NO. 412-05-115

SUBJECT: AERONAUTICAL ACCESSORIES, INC. ASB No. AA-03017 FOR EXTERNAL HOIST KITS P/N 412-130-XXX, 412-140-XXX OR 412-150-XXX.

ASB No. AA-03017

REVISION A

Figure 1

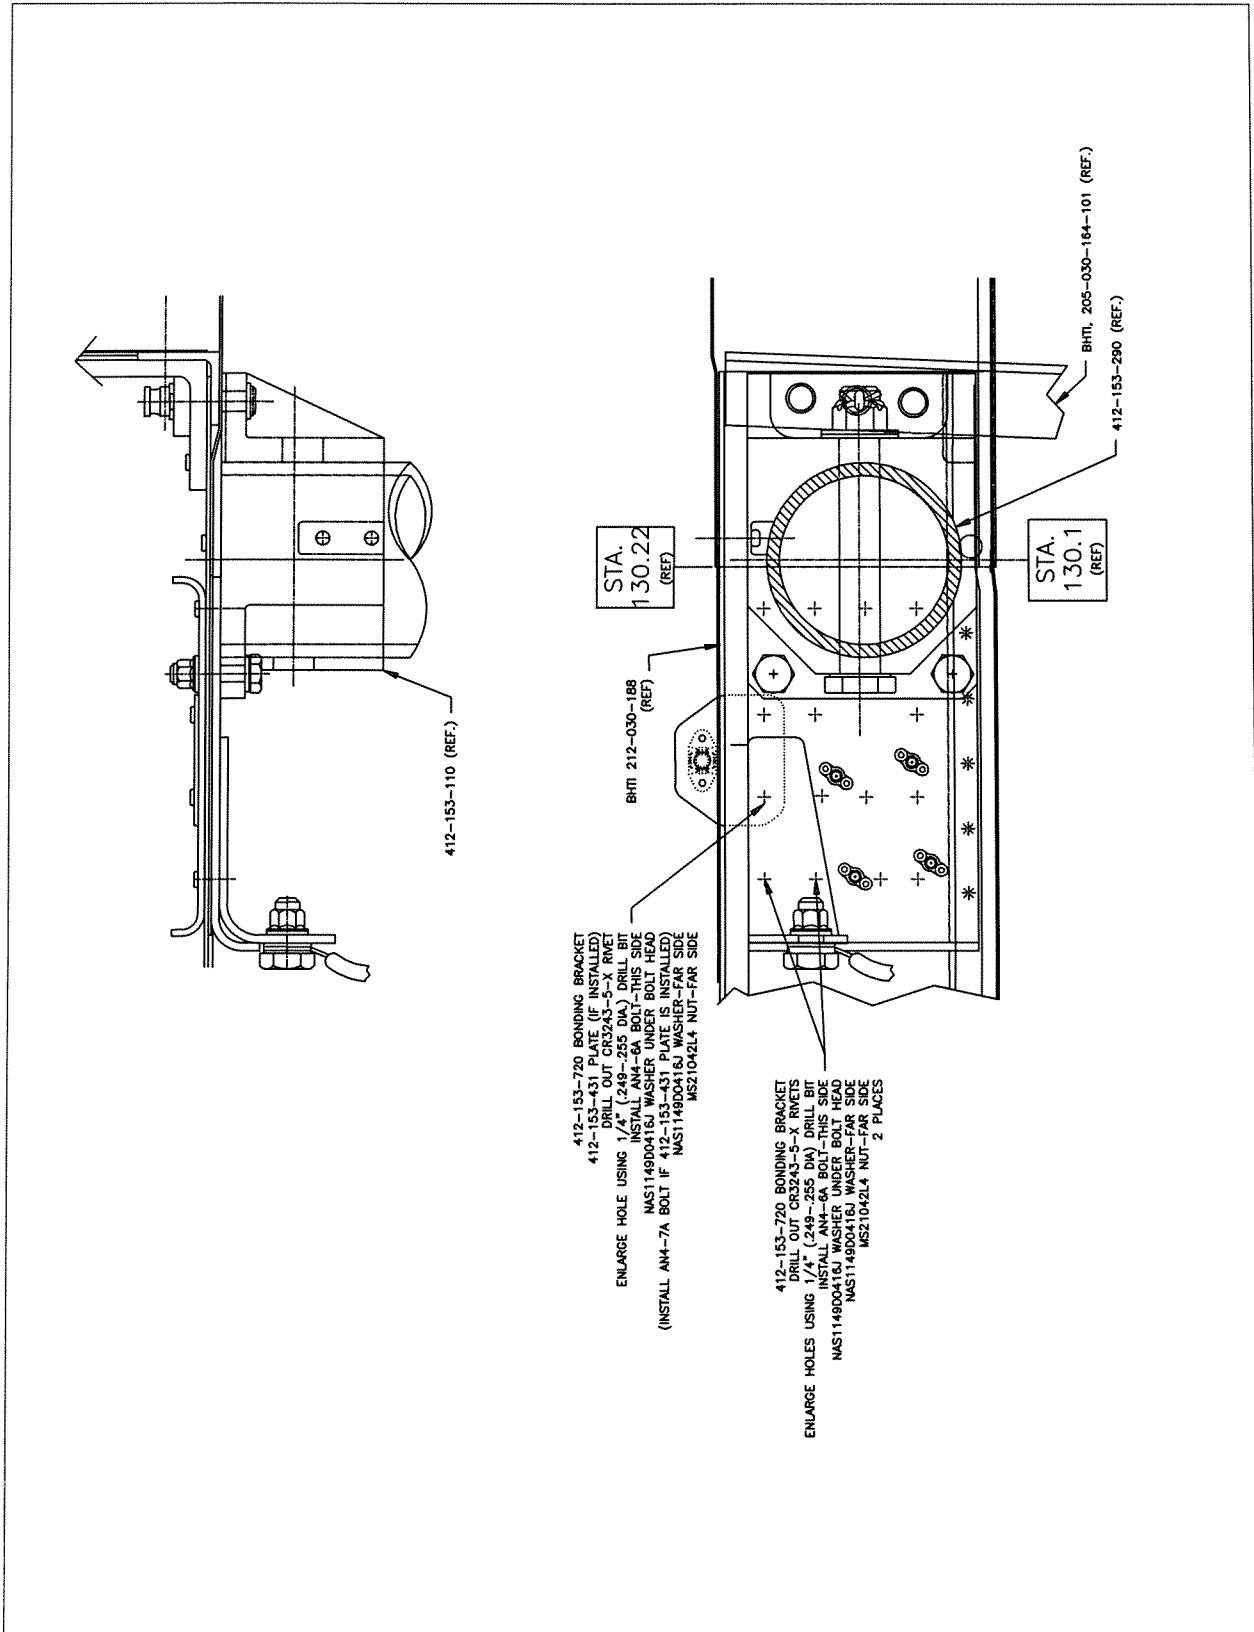
1. Locate Bonding Bracket (412-153-720) as shown in Figure 1.
2. Remove any existing blankets or trim to gain access to the area. Retain for reinstallation.
3. Drill out the three rivets attaching the Bonding Bracket to the airframe (Ref. Figure 1).

4. Increase the diameter of the three remaining holes by using a 1/4" (.249-.255 dia.) drill bit.

5. Using 100 grit sandpaper or dual action sanding, incrementally remove up to a maximum of .005 from the backside of the Bonding Bracket. Wipe the exposed surface with clean cheesecloth. The cheesecloth shall be either dry or wetted with isopropyl alcohol.

6. Apply a coating of chemical conversion coating (MIL-C-81706, Class 3 or equivalent) to the bond surface using a nonmetallic brush. Allow coating to remain on bond surface for 5 seconds maximum. This produces a light iridescent yellow finish on the bond surface.
7. Remove excess chemical conversion coating from the bond surface by blotting with a clean dry cheesecloth. Allow the bond surface to air-dry or gently wipe bond surface with cheesecloth.
8. Install Bolts, Washers and Nuts as shown in Figure 1.
